Change Notice

PCN No: 132

Notice Type: Product Revision Change

Product Type: RL208

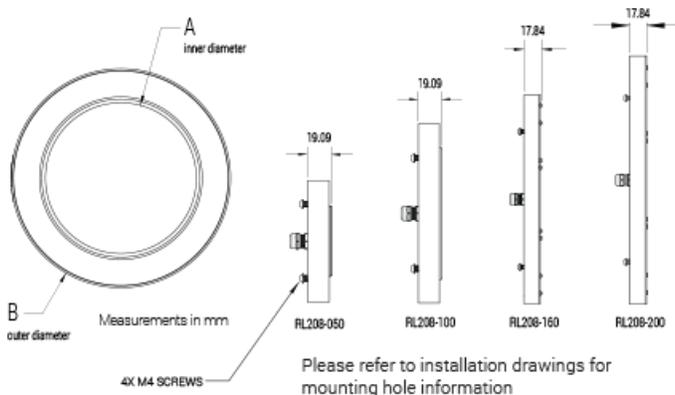
In an effort to improve our products, Advanced illumination (Ai) will update the LEDs used in the RL208 design. This change will result in a brighter, more uniform light at the same price*. Customers may still buy the current revision of this model until July 22th of 2016. After that time, orders for these products will be converted to their respective RL208 Revision A models.

This LED change will result in additional wavelengths being available: 365nm, 375nm, 385nm, 395nm, 405nm, 470nm, 505nm, 590nm, 660nm, 730nm, 850nm and 940nm. Additionally the white LED color temperture will be changing from 6100K to 5500K.

*UV wavelengths (365nm, 375nm, 385nm, 395nm & 405nm) will be sold a higher list price, which will be released at the time of product introduction.
